NEW GENERATION OF AIR COMPRESSORS FOR THE VOLVO GROUP

Compressor 912 512 029 0

COMPRESSORS FOR VOLVO GROUP

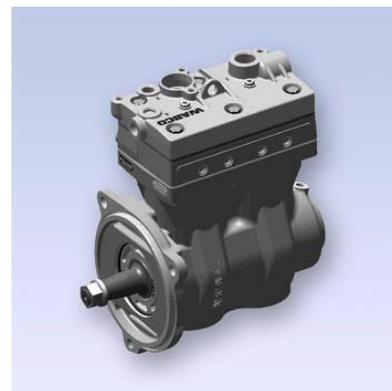
Compressor lifetime will be increased thanks to the:

- Reduction of carbon-build-up (CBU) behavior of the compressor by Introduction of CBU-reduction holes for improved cooling performance of cylinder head
- Implementation of optimized power reduction system (OPR)
